# **ACCESS REPORT**

**Reference Number:** 23182

**Site Address:** Homes NSW – 48 New Orleans Crescent,  
Maroubra, NSW

This Access Compliance Report is to accompany a Part 5 application for the development proposed at **Homes NSW – 48 New Orleans Crescent, Maroubra, NSW**

**Ground floor plan**

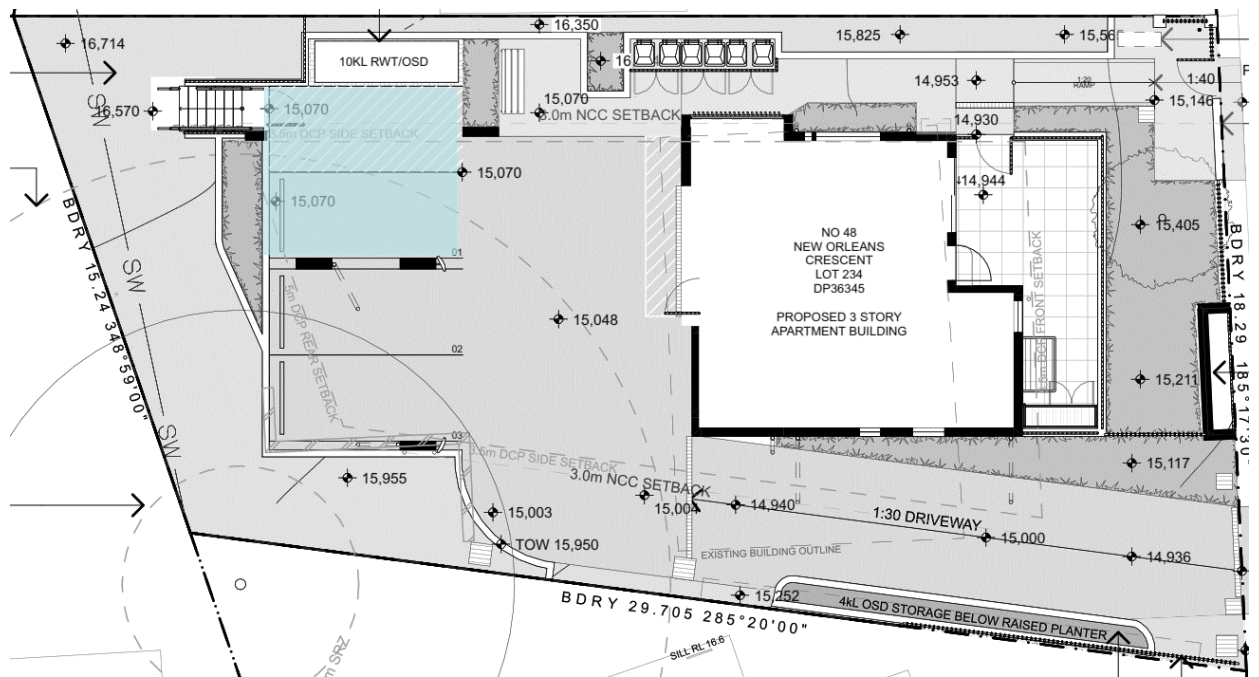
The development proposes 1 Adaptable unit.

Therefore, 1 accessible carparking space is required for the residential component of the development.

1 Accessible car parking space has been provided in development. allocated to the Adaptable unit.
